URGENT FIELD SAFETY NOTICE

RE: SINGLE USE LIGATING DEVICE POLYLOOP

Material ID	Model Number	Material Description	Lot Numbers	UDI
N5382130	HX-400U-30	SINGLE USE LIGATING DEVICE POLYLOOP	All Lots	04953170368615

Figure 1

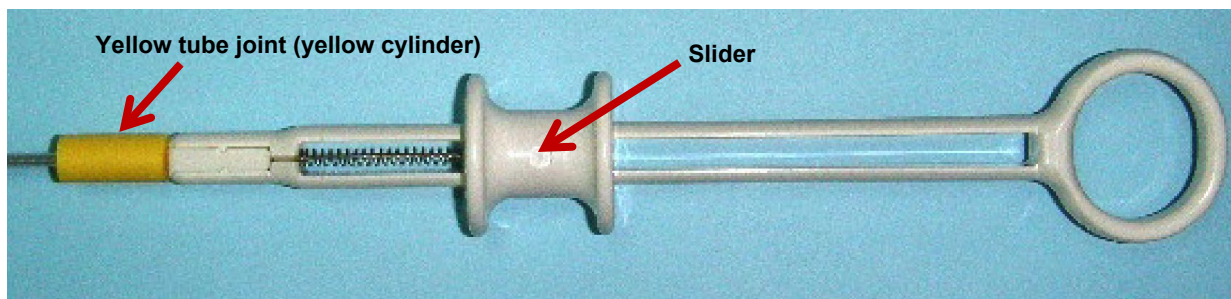
- Inadvertent or intentional movement of the yellow tube joint (cylinder) away from the device handle during use. Intentionally moving the yellow tube joint away from the handle to prematurely tighten the loop during use may cause the inability to release the ligation loop. (See figure 1 below.)

■ **Operation when ligating tissue (refer to page 6 in the manual)**

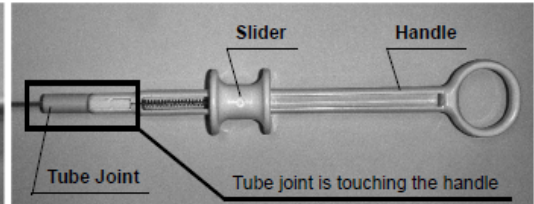
- Pull the tube joint until it touches the handle to extend the loop from the tube sheath.
- Confirm the endoscopic field of view to see that the coil sheath is extended from the distal end of the tube sheath.

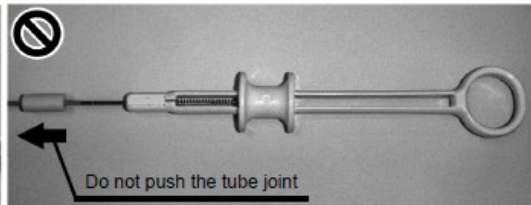
■ **Do not hold the loop with the distal end of the tube sheath while the loop is surrounding the tissue. (refer to page 5 in the manual)**

Otherwise, when the tissue is ligated, the loop may be detached from the hook in the tube sheath and tangled with the hook.

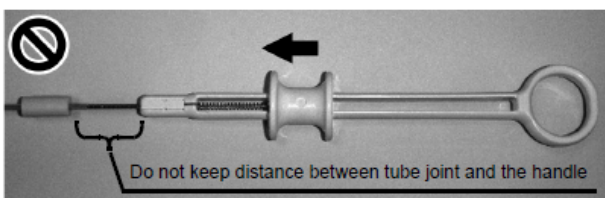
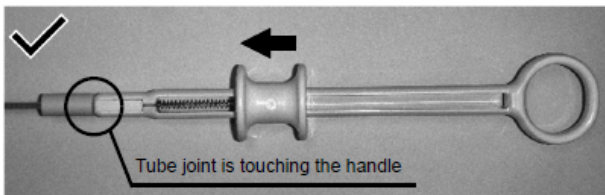
- ***Do not remove the loop from the hook while the coil sheath is not extended from the tube sheath. (refer to page 6 in the manual)***

Otherwise, the loop may be tangled with the hook and become impossible to be removed.

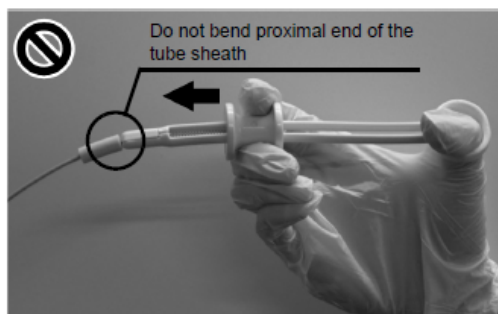
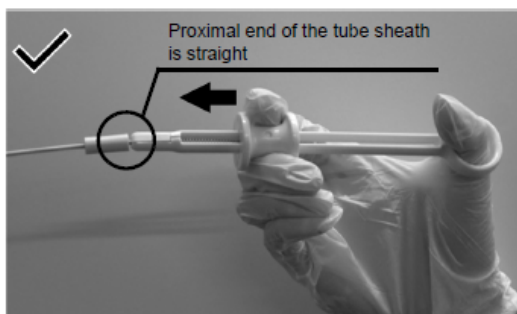
- ***With the proximal end of the tube sheath and handle kept straight against the biopsy valve of the endoscope, push the slider when detaching the loop. (refer to page 6 in the manual)***

Bending the proximal end of the tube sheath will increase frictional resistance, which may damage the handle when pushing the slider.
